Laclede County BRO-B053(13)
Project Job #3884

ADDENDUM No. 01

DATE: July 17, 2018

RE: **Laclede County BRO-B053(13)
Bridge #28100211**

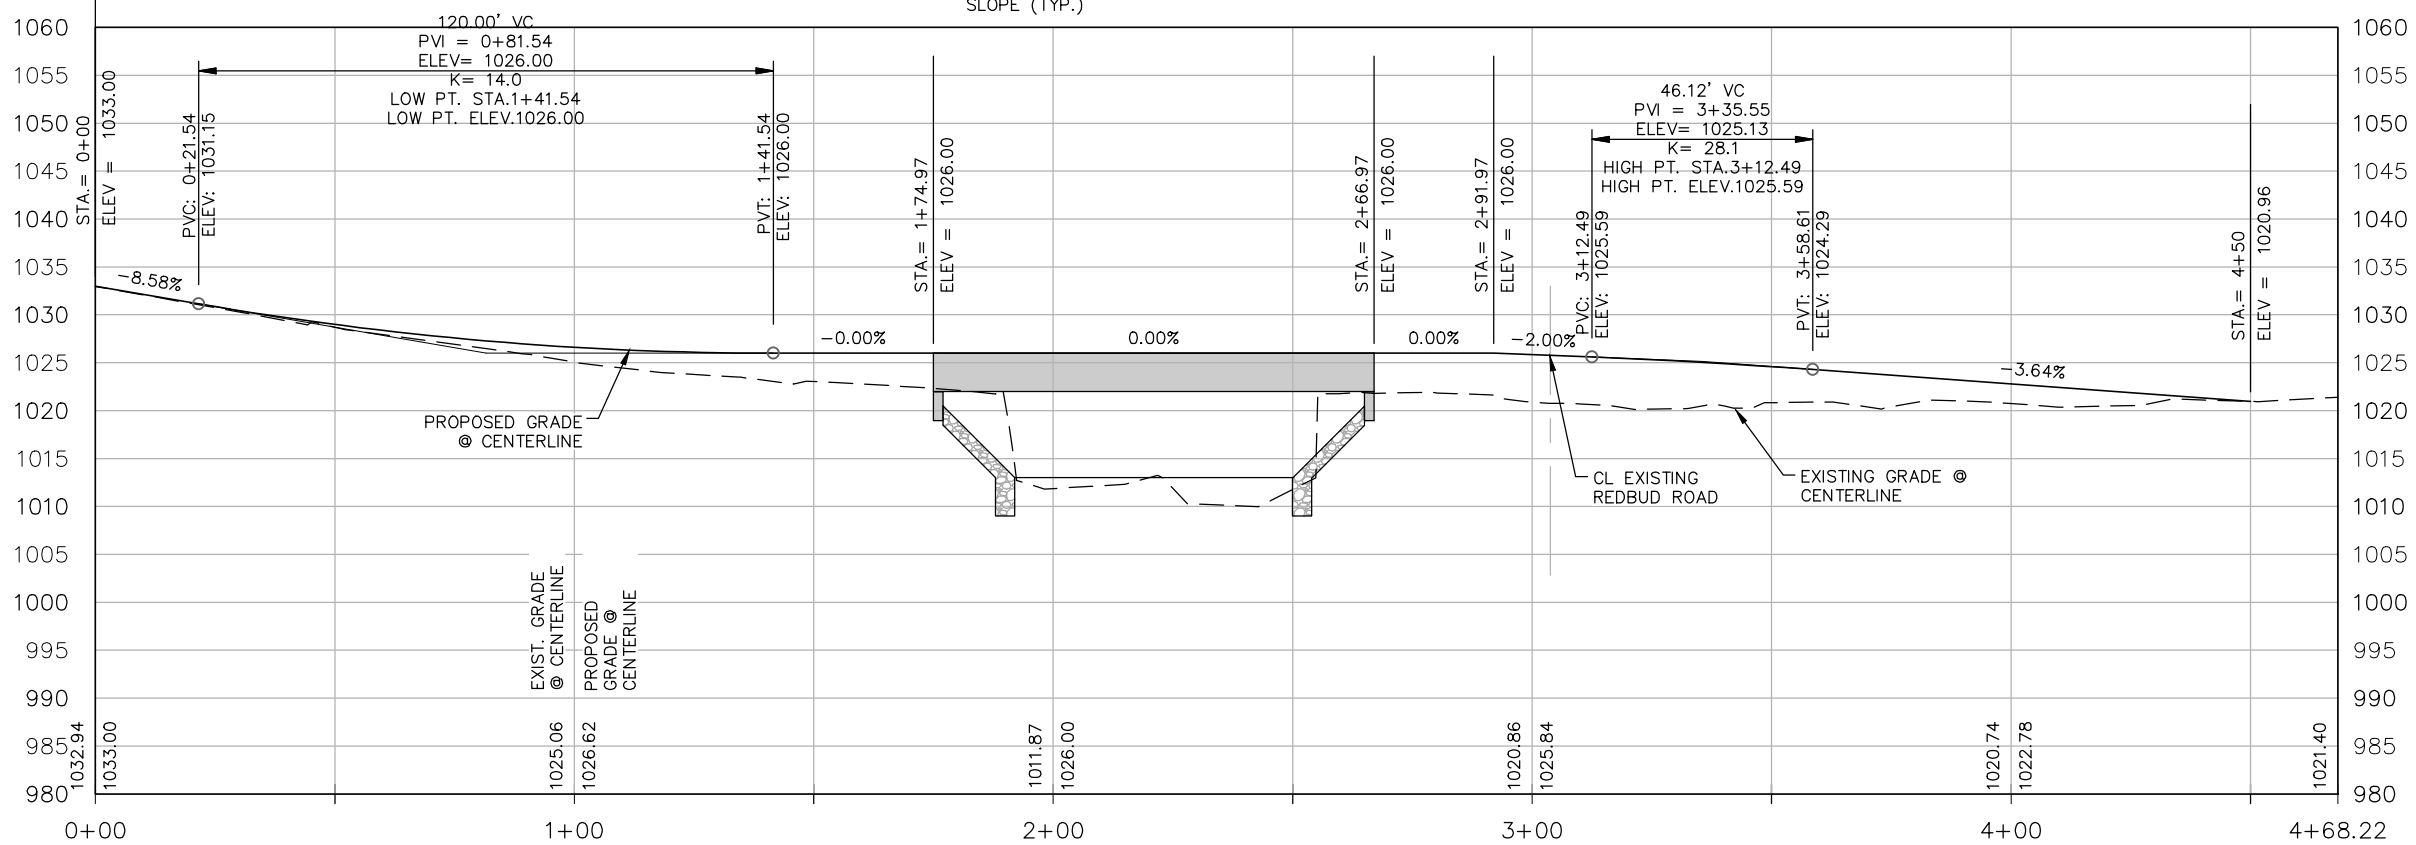
- Plan Sheets C2, C4, C5, and C6 have been updated to include Type A Guardrail on the SW approach. Use revised sheets.
